TECHNICAL SERVICE BULLETIN

Drivers Seatbelt Locking Up And Difficult To Extend

21-2054
04 March 2021

Lincoln 2017-2020 Continental

Figure 3

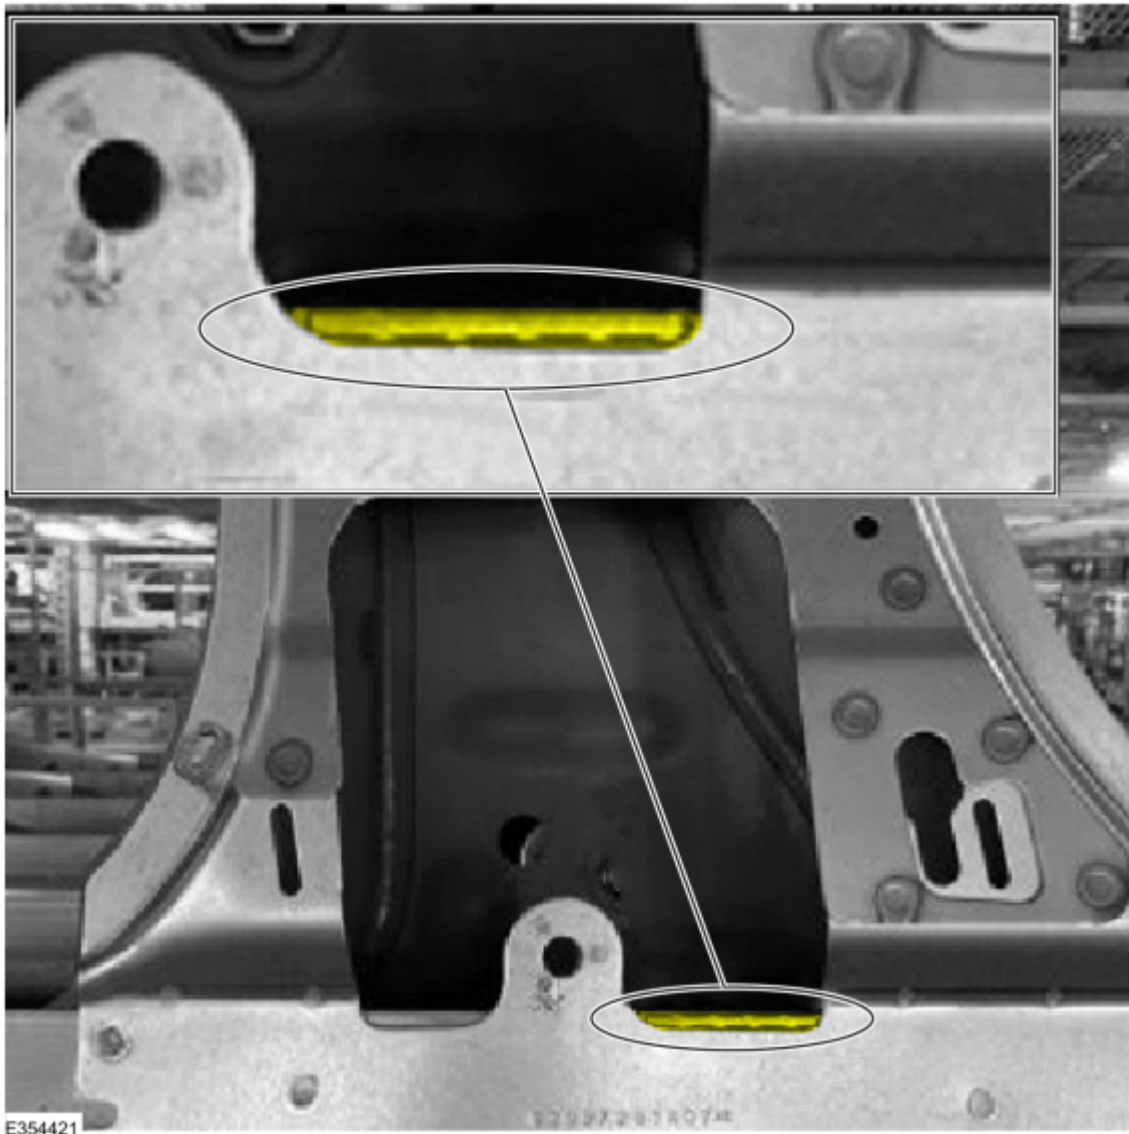
- 3.** Was interference found between the seatbelt retractor pretensioner assembly and the B-pillar sheet metal?
 - (1). Yes - proceed to Step 4.
 - (2). No - this article does not apply. Refer to WSM, Section 501-20A for normal diagnostics.
- 4.** Remove the seatbelt retractor and pretensioner assembly only. It is not necessary to remove the upper B-pillar trim, the seat belt D-ring or seatbelt anchor bolt. Refer to WSM, Section 501-20A.
- 5.** Using a suitable tool, remove approximately 2 mm (0.0787 in) of the B-pillar flange overlap to allow clearance between the seatbelt retractor and B-pillar sheet metal. (Figure 3)

6. Apply corrosion protection to the areas where the existing paint has been removed. Refer to WSM, Section 501-25.
7. Reassemble the vehicle. Refer to WSM, Section 501-20A and 501-05.
